Subject: **Response to Portion of NRC Request for Additional Information  
Letter No. 43 Related to ESBWR Design Certification Application –  
Containment Fragility – RAI Numbers 6.2-96, 19.2-39, 19.2-40, 19.2-  
42, 19.2-43, 19.2-47, 19.2-48, 19.2-51, 19.2-52, 19.2-53, 19.2-54, 19.2-55,  
19.2-66, 19.2-67 and 19.2-68**

**ENCLOSURE 1**

**Containment Fragility**

**RAI Numbers 6.2-96, 19.2-39, 19.2-40, 19.2-42, 19.2-43,  
19.2-47, 19.2-48, 19.2-51, 19.2-52, 19.2-53, 19.2-54,  
19.2-55, 19.2-66, 19.2-67 and 19.2-68**

Figure 19.2-47(1) Temperature Distributions for Normal Operating Thermal Conditions

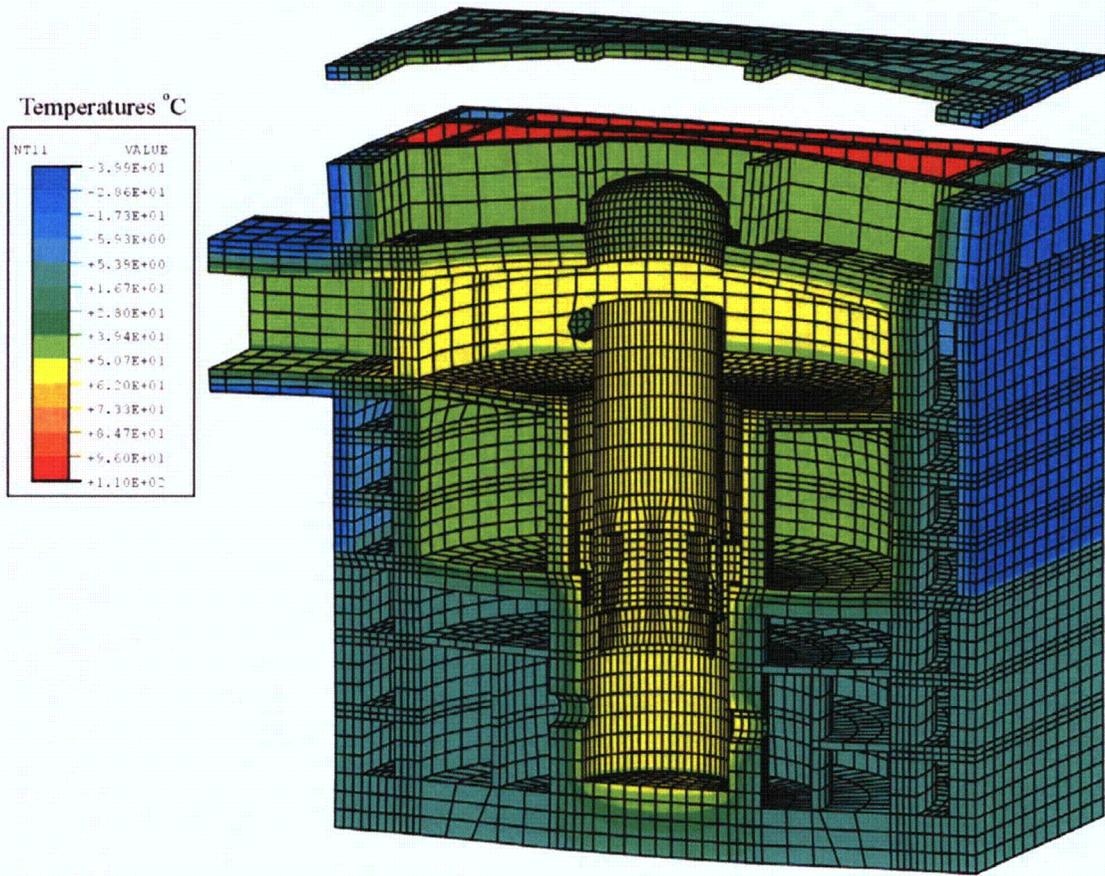
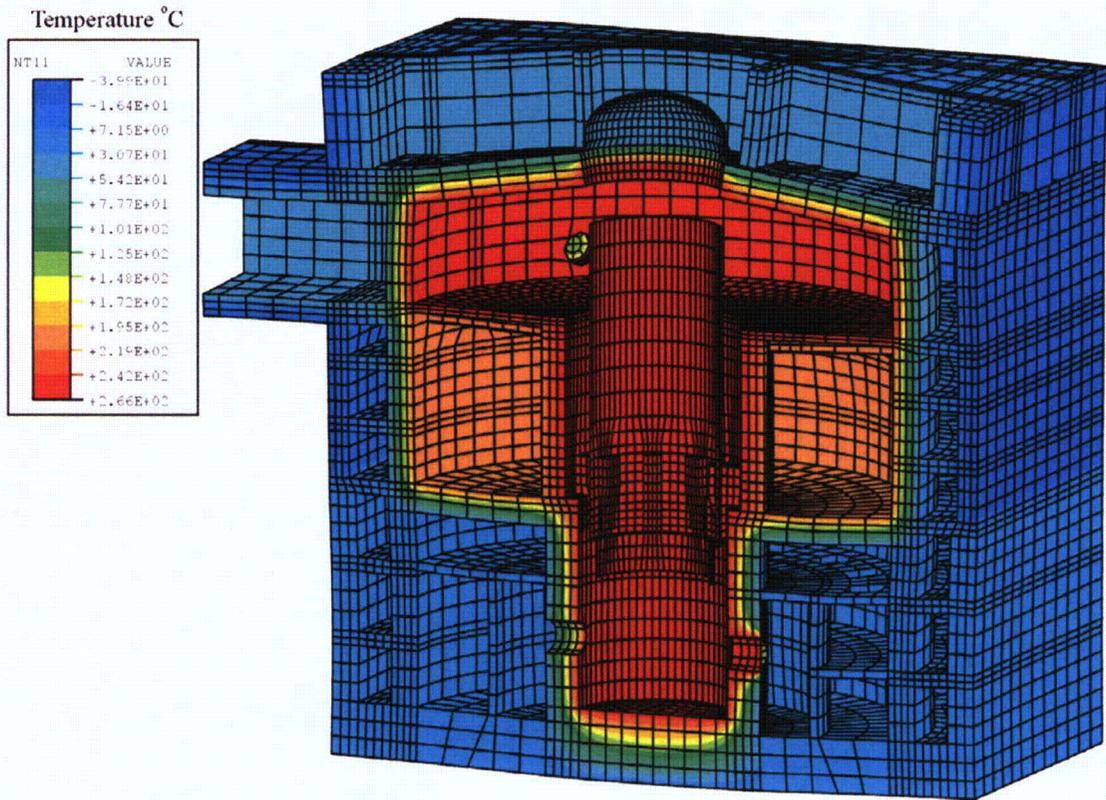
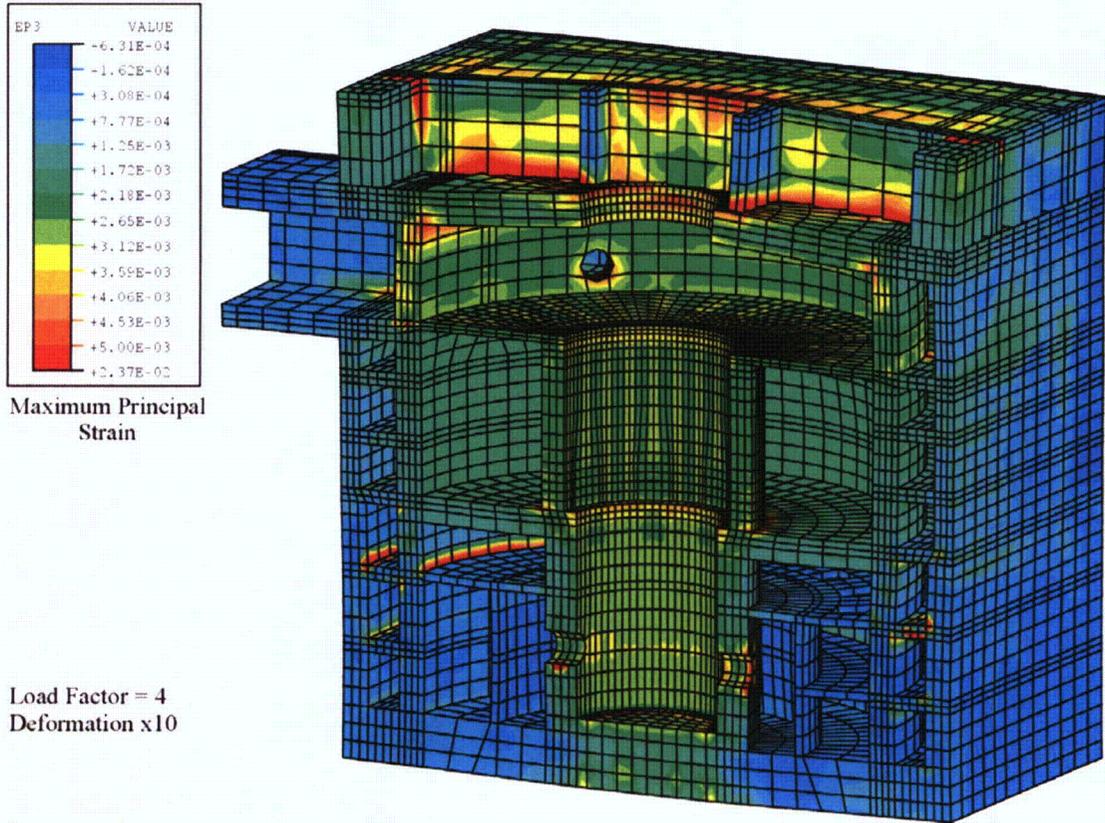
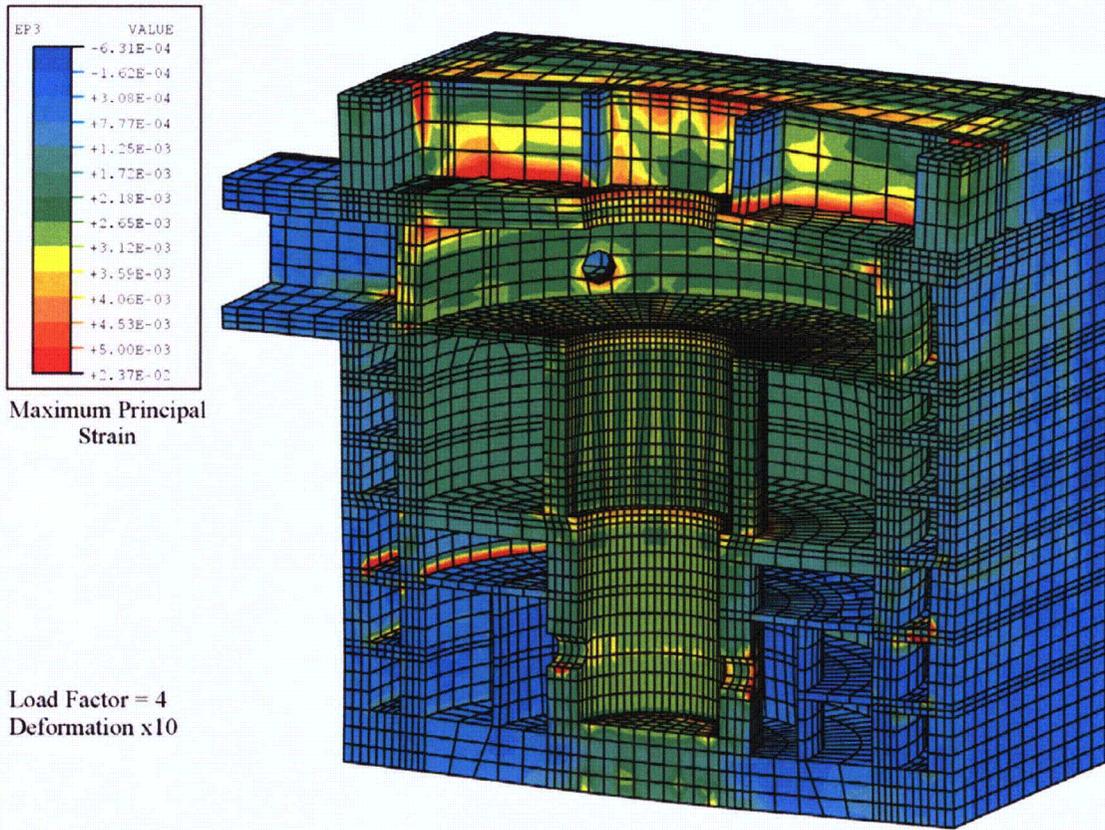
*In PRA Appendix B.8.2.1, GE provides an estimate of containment pressure capacity at 500 °F temperature. This estimate was based on an ANL study, which concluded that the failure pressure for RCCV at temperatures up to 700°F was reduced by about 11% from that predicted at ambient temperature, for pressure load alone. Provide:*

The results are applicable to the ESBWR analyses provided in Appendix B.8.2.1 because they are applied in a consistent manner. This static capacity analysis is based on an axisymmetric model for the global failure of the RCCV. The capacity of the RCCV is not expected to be the limiting capacity of the ESBWR primary containment system, and the mode of this global failure under internal pressure is not expected to change with temperature. While the failure mode in the axisymmetric model for the ESBWR is found to be section shear capacity at a horizontal floor connection (rather than hoop rebar capacity), a similar reduction in capacity due to concrete and rebar property degradation at temperature was deemed appropriate. Some conservatism is included in adapting the 10% reduction in pressure capacity at elevated temperature from the ANL study to the ESBWR axisymmetric global analysis. The ANL study found an 11% reduction at 700 °F, whereas the ESBWR analysis considers a 10% reduction for a 500 °F condition. In addition, for the section shear capacity failure mode, the thermal loading also has a counteracting effect to the material property degradation. Any additional compressive stress acting on the section due to restraint against thermal expansion will increase the shear capacity of the section.

- c) The design envelope for temperature, which is a bound on possible maximum anticipated temperatures, during a LOCA includes an initial spike to 171 °C (340 °F) and a long term temperature of 150 °C (302 °F). The best estimate temperature history for a large break leading to DCH conditions, see response to RAI 19.2-57(1), considers a temperature spike of ~1600 °C lasting only a few seconds, with a long term equilibrium temperature of about 200 °C (392 °F). Based on these severe accident temperature histories, the steady state temperature distribution with the liner at 500 °F is considered a representative maximum accident temperature distribution with regards to the containment pressure capacity. The pressure capacity for the RCCV is most affected when temperatures penetrate well into the wall depth because the strength reduction is most affected by material degradation at elevated temperature. Even a much higher temperature spike that lasts only a few seconds will have little effect on the pressure capacity because the temperatures within the RCCV wall are not affected. Note that in the ANL study, the pressure capacity for the 700 °F transient thermal distribution case was higher than the 400 °F steady state distribution case.

Figure 3G.1-51. Drywell Head

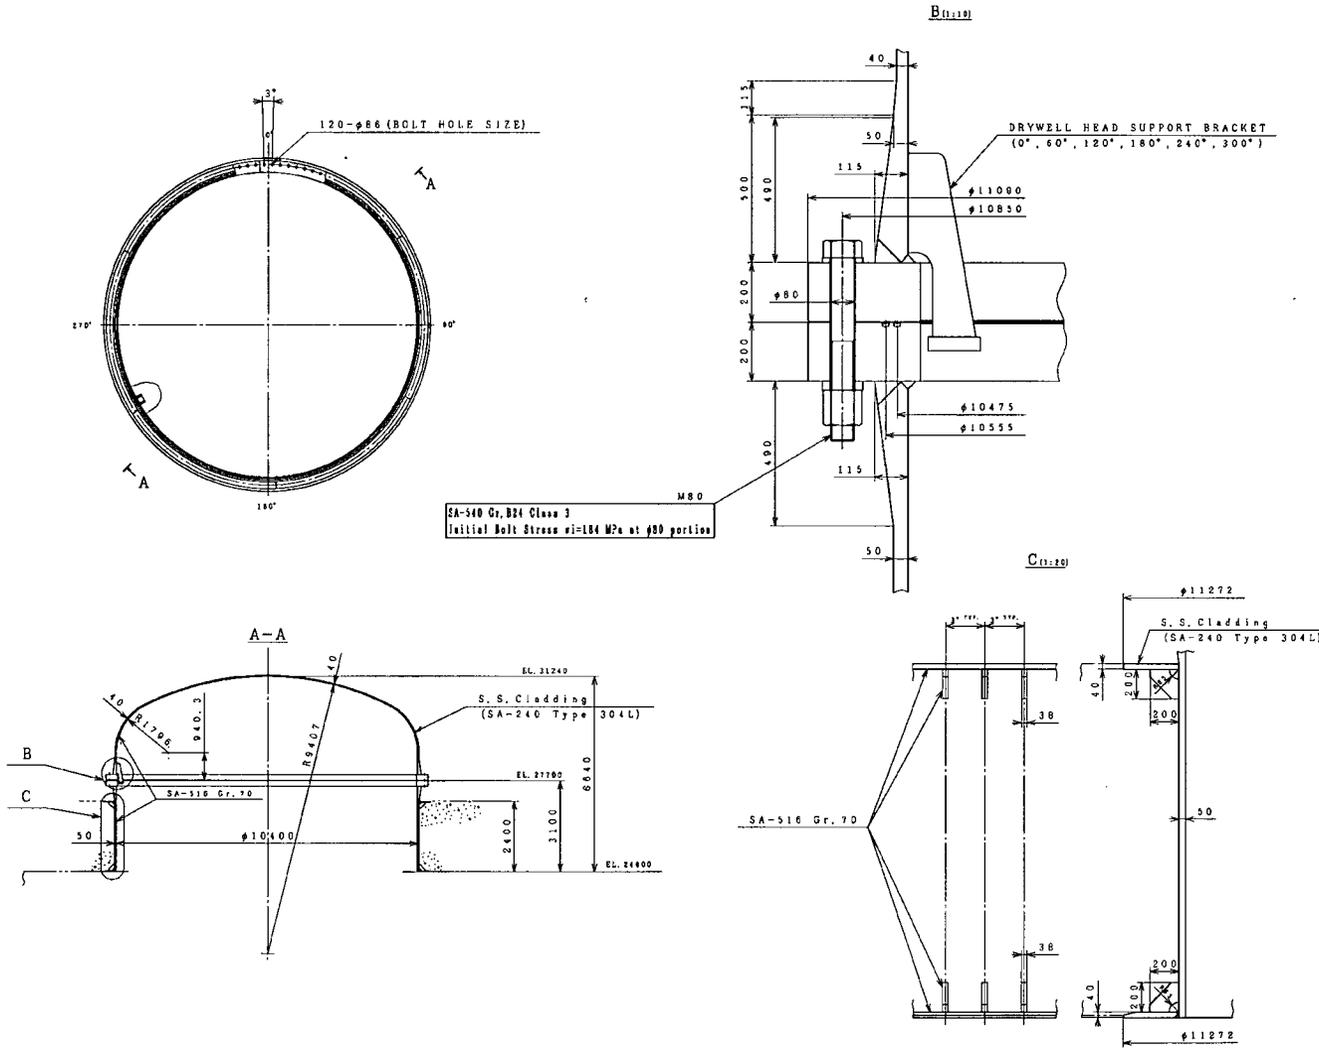
- a) In determining the Service Level C pressure capability for the drywell head, how was the primary axial load path through the bolted flange closure (DCD Figure 3G.1-51, Detail B), to the anchored support cylinder (DCD Figure 3G.1-51, Detail C), and into the concrete evaluated?*

Bolted flanges of the drywell head, drywell and wetwell hatches have been strengthened to achieve no leakage potential under severe accidents for pressures up to the containment ultimate capability pressure. This is an example of design improvement resulting from PRA insights. PRA report Sections B8, B8.2.2.2 and B.8.2.3 will be revised in the next update as shown in the attached markups.

Figure 3G.1-51 of DCD Tier 2 Appendix 3G will be revised in the next update as noted in the attached markup.

In addition, Figures 3G.1-51 through 3G.1-53 of DCD Tier 2 Appendix 3G will be revised in the next update as noted in the attached markup.
